Town of Brookline

PLANNING BOARD

To: Brookline Board of Appeals
From: Brookline Planning Board
Date: February 12, 2015
Subject: Construct a five-car parking area to the rear of the building (**revised to four-car garage**)
Location: 1471 Beacon Street

Atlas Sheet:	42	Case #:	2014-0070
Block:	214	Zoning:	M-2.5
Lot:	26	Lot Area (s.f.):	±7,613

1 Garage Plan

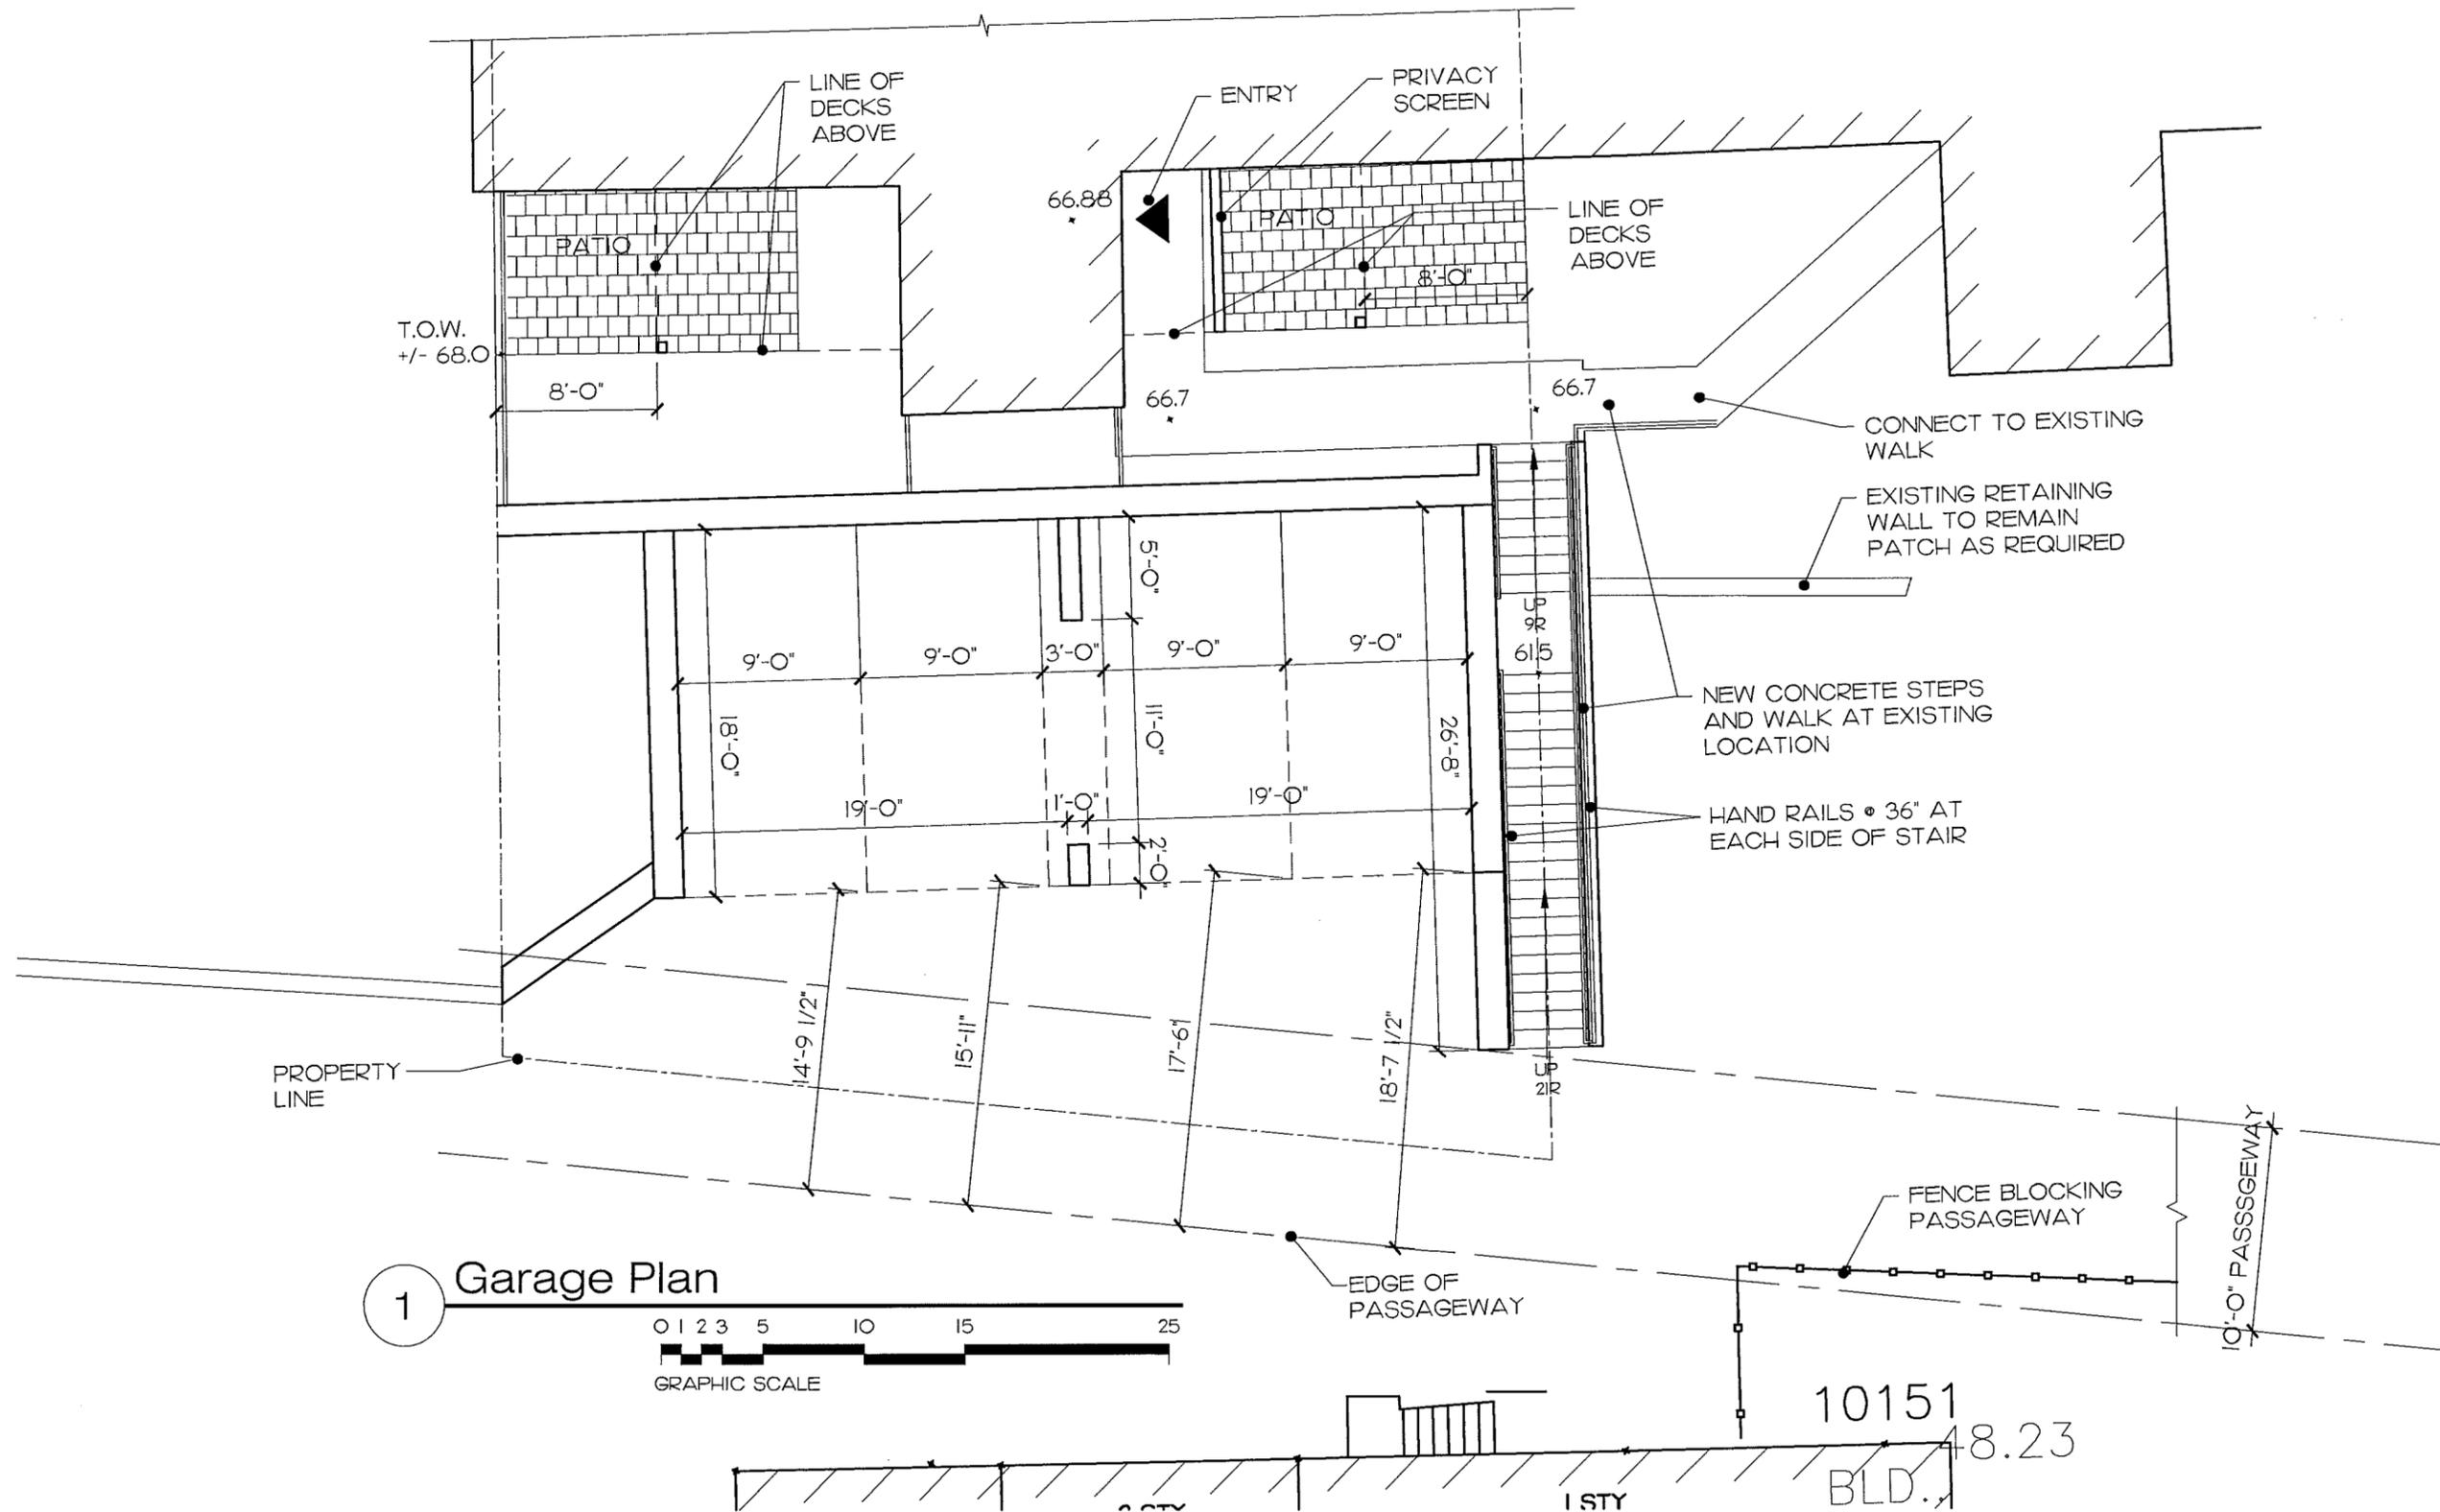
e. Circulation – The proposed garage will use a 10'-wide easement at the back for access. The garage entrance will be setback from the property line (easement center line) by 5'. The Planning Board is not convinced there will be enough space to back out of the garage without crossing the easement and infringing on the property to the rear.

A minority of the Board felt that though the revised proposal with four parking spaces was an improvement from the initial proposal, it still did not meet the standards for special permit relief; the location is not appropriate for a four-car garage, which would adversely impact pedestrians and vehicle movement. Since the right of way is only 10 feet wide, there is not enough space for vehicles to pass each other as well as maneuver and park. The landscaped area at the rear is the only buffer between the smaller scale residential dwellings on Griggs Terrace and the larger multi-family development along Beacon Street, and it is not clear what the counterbalancing amenity for this proposal would be.

2. Prior to issuance of a building permit, the applicant shall submit a circulation plan for the parking area, subject to the review and approval of the Director of Transportation and Engineering.
